LETTER OF SUBMITTAL
 KFM Skyway Project # **04-012024**

Subject: **USI** - Documents Clearing **USI** KFM NCR #71 (METS 57)

Subject: USINCR No. 57: Failure to Provide Details For Proposed Method of Straightening

Re: State letter no. 5.03. 01-006031, KFM NCR 71, **USI** NCR No. 57,
regarding Soffit plates pa19 and pa20 fabrication steps.

Photo taken after clamps were taken off, 11/05/2004

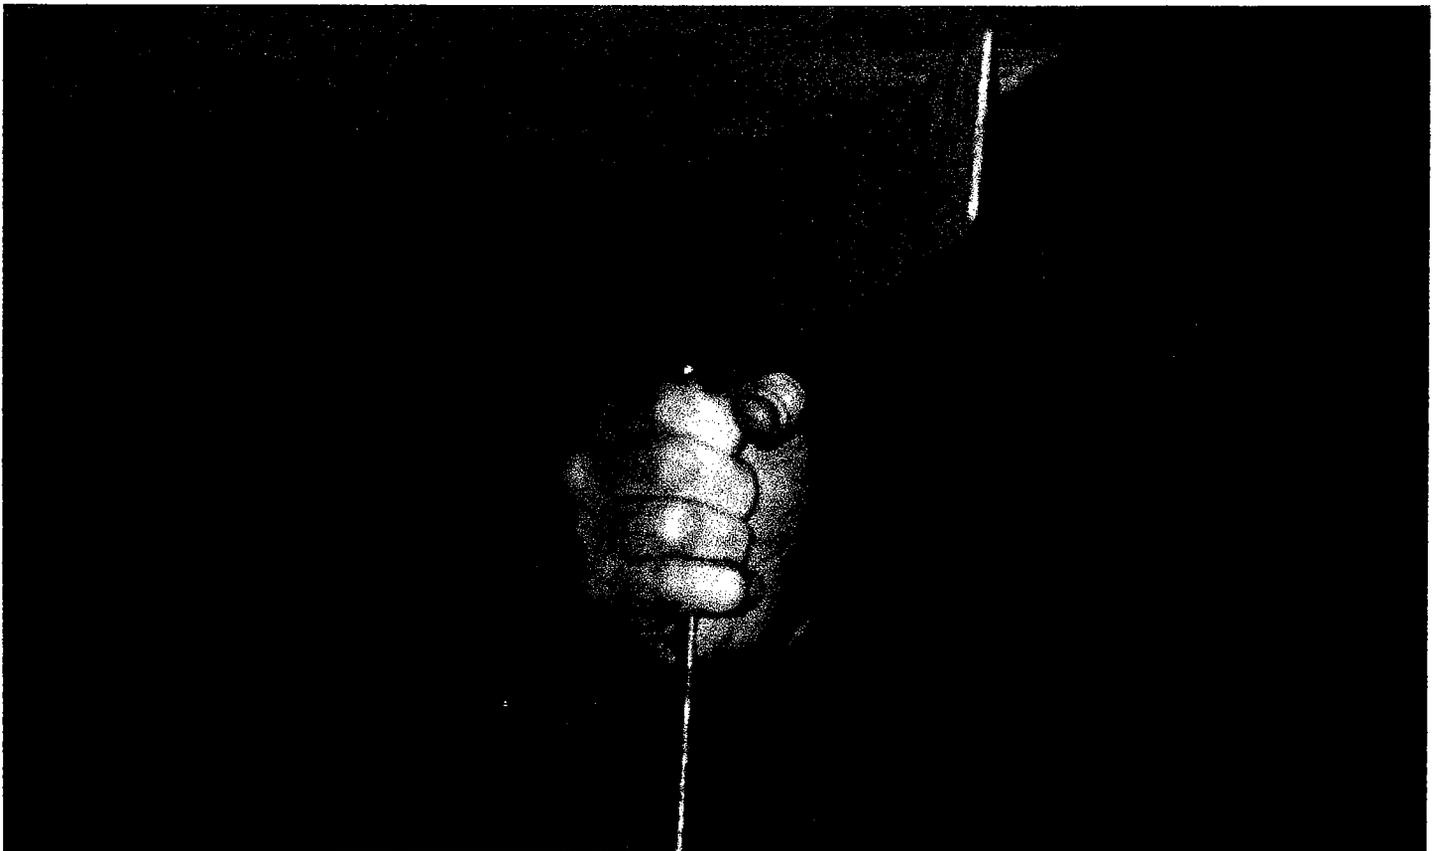
1. The State QA inspector observed USI straightening soffit plate pa19 at weld joint **102** which is a fracture critical member. The plate distorted **while** in the process of welding **pa50** to pa19. In order to weld stiffeners pa19 and pa50, USI proceeded to use clamps and devices utilizing portable hydraulic power to straighten the distorted plate. Section 55-3.02 'Straightening of Material' of the 1999 Standard Specifications states, "If straightening is necessary, it shall be done by methods acceptable to the Engineer. Details for methods proposed for straightening shall be submitted in writing to the Engineer prior to their use."

We are in receipt of the above referenced letter stating that **USI** failed to provide details for proposed method of straightening. In this instance of pa19 at weld joint 102, **USI** restrained the joint where weld distortion was being encountered. This was the first joint where this particular configuration was being welded. More distortion was found than what was originally thought. This was primarily due to the weld prep used by the detailer on the shop drawing. This preparation has subsequently been revised to a prep that **will** have an equal amount of heat input on both sides of the weld to reduce distortion. Additional restrains will also be used to limit distortion.

The procedure used by **USI** to restrain the weld joint is not straightening. It is our position that straightening is defined as yielding the material so it takes a permanent shape. This would be done using heating methods to reshape the material. In this case, no heat was used; the material was brought back into alignment by mechanical means to assure compliance with dimensional tolerances for both the weld and stiffeners that would be fit at later date. The material was not yielded, in other words, if the restraints were to be removed, the material would have returned to its shape before restraints were applied. This was checked to make sure we were not yielding the material. This is the same distortion that would have been encountered had the restraints been applied prior to the start-up of welding on this particular joint.

The Engineer has reviewed KFM-SUB-003680R00: USI Documents Clearing USI KFM NCR #71 (METS #57). The Engineer agrees the Contractor has sufficiently addressed this NCR. As a result, USI NCR No. 57 is resolved.
